STAFF REPORT: MAY 14, 2025 MEETING 5/13 Correction made on page 9

APPLICATION NUMBER: HDC2025-00193

ADDRESS: 2012 WABASH

SCOPE: ERECT SINGLE-FAMILY DWELLING, INSTALL ROOFTOP SOLAR PANELS

Applicant's renderings and site plan of the proposed dwelling.

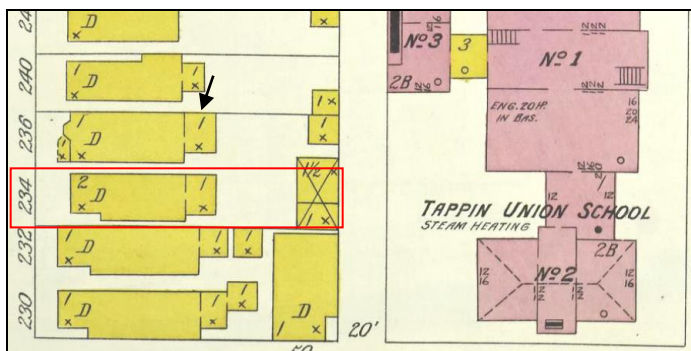
- A tall flat roofed dwelling with an added gable-roofed penthouse creates an overall massing that is not compatible to the surrounding dominant front-gabled dwellings.

- The erection of a four-sided third floor/rooftop patio is an atypical feature in Corktown. It is staff's opinion the open-sided railing is in the spirit of the Victorian-age "widow's walk" which was a common design features for east coast homes.

- The required penthouse as an incompatible shape and massing for this residential street, and the patio railing creates an additional design element, all of which is in sharp contrast with the 19th century houses and in conflict with Standard 9 which states "*new work shall be differentiated from the old and shall be compatible with the massing, size, scale, and architectural features to protect the historic integrity of the property and its environment*". Staff will request additional visual studies from different angles/distances to determine how visible, or not, this third level patio and penthouse will be from a greater distance.

Applicant drawing – Building section. Comparing the height of each level (from floor to floor):

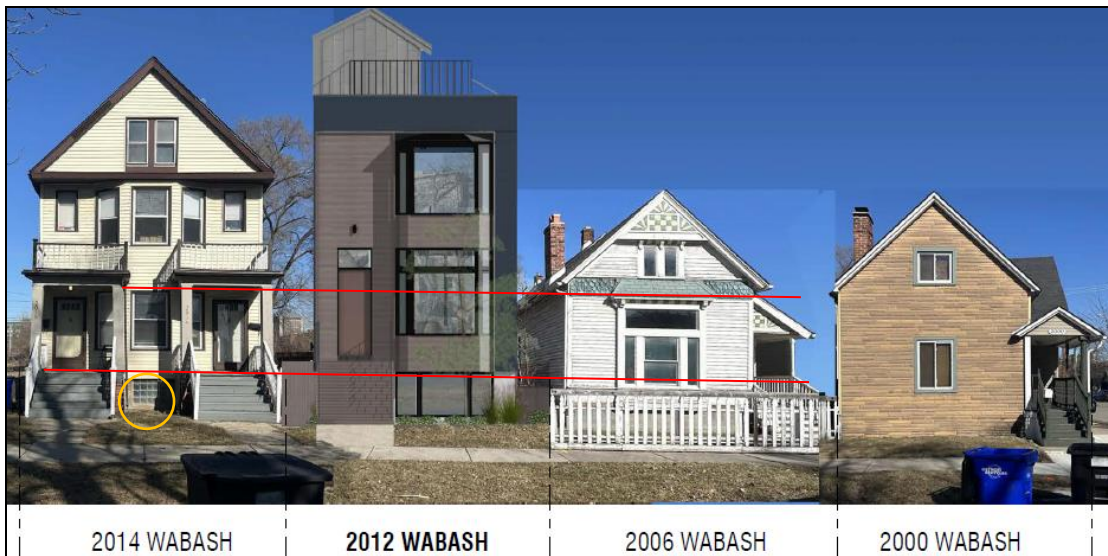
- Most residential houses are one-story to 2 ½ stories tall. With the raised basement and penthouse that leads to an open deck, the finished height of this dwelling is 39', which equates to a three-story house. The rectangular massing, coupled with the rooftop penthouse, creates an imposing structure in relation to the adjacent 1 ½ - and 2 ½-story dwellings.

Applicant photo/rendering.

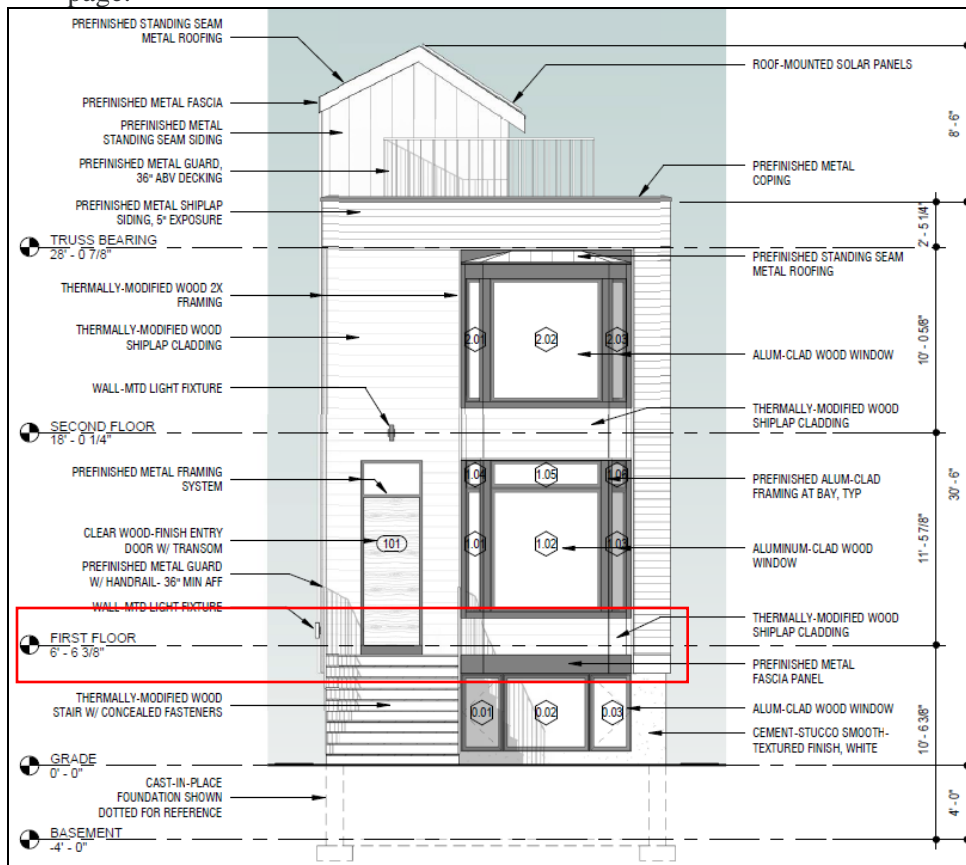
- The dominant façade patterns of the historic houses on this block include front-facing gables (open and closed), bay windows, recessed entrances, covered porches and taller than wide windows. The proposed dwelling does nicely combine elements of the flanking bay windows (the two-story bay element at 2014 Wabash and the transom window within the façade window opening at 2006 Wabash). However, the remaining features on the historic houses are not referenced in any way, and the predominately flat-faced façade and flush front door further emphasizes the dwelling's verticality.

- The three historic houses all have raised basements, but the basement at 2014 Wabash is the tallest, allowing for large window openings. This creates a slightly higher first level floor height in contrast to the 1-½ story houses to the south. However, the top of the first floor bay window at 2014 Wabash is aligned with the top of the exceptionally large window at 2006 Wabash, minimizing the height different of the first floor.
- As shown below, the new dwelling's first floor exterior cladding of the bay window extends below the finished floor, thus creating visual alignment with the floor height of 2014 Wabash. However, the impact of the raised basement and increased ceiling heights of the interior rooms, causes the window openings to be out of alignment with the neighboring houses, as outlined in the photo at the bottom on the previous page.

The applicant's dimensioned drawing shows how the exterior wall of the bay window extends below the interior's finished floor height, allowing for visual alignment with the first floor (and exterior porch floor) at 2014 Wabash.

Above: Applicant visual study. Right: Detroit Parcel Viewer

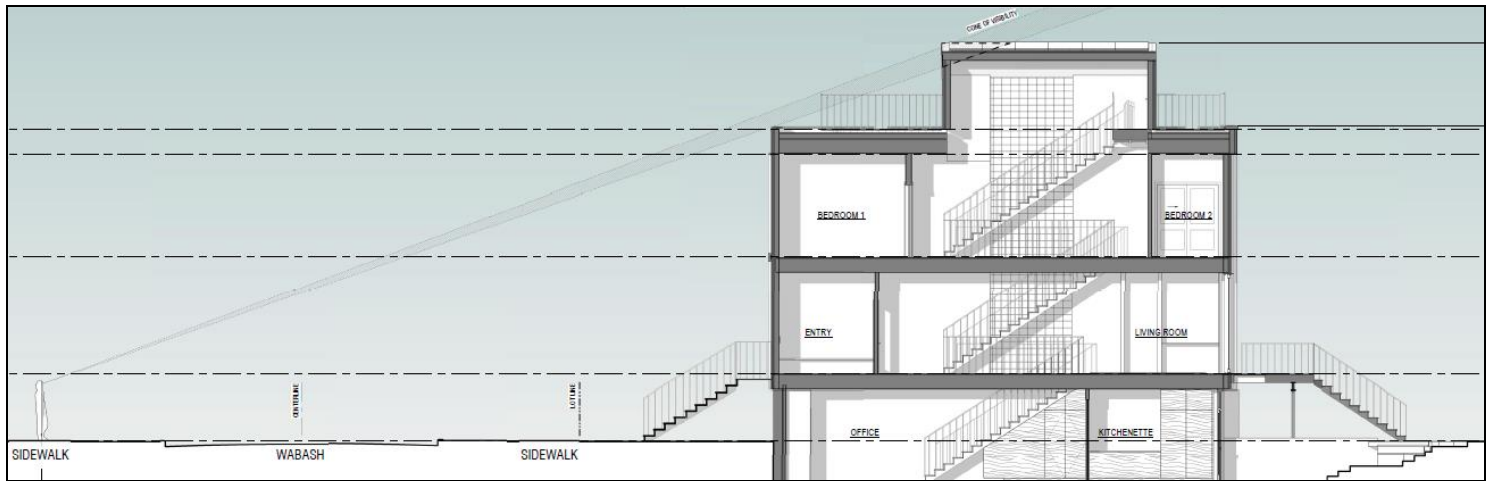
- The applicant supplied this visual study to show the portions of the rooftop patio railing and penthouse that will be visible from the west side of Wabash. Staff believes additional studies should be submitted for the Commission to understand how visible these elements will be from north, south and east views. The east view will be highly visible as Mullett Park is behind this lot.

Applicant roof plan.

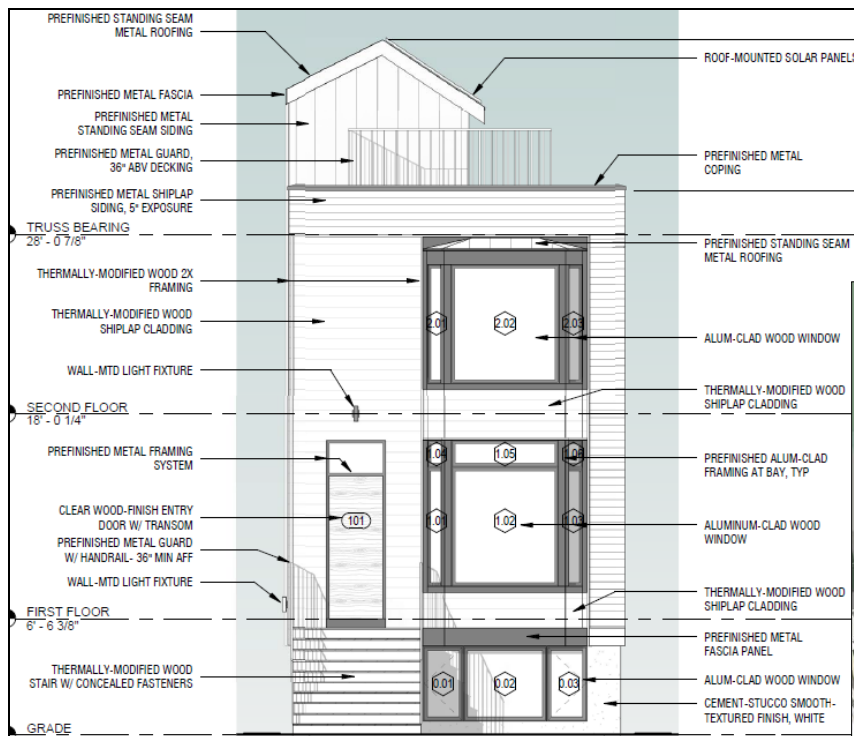
- Solar panels are proposed for the third floor. The roof plan and elevation shows panels on the south-sloping roof, however the rendering shows an additional array on the flat roof, between the patio and roof edge.
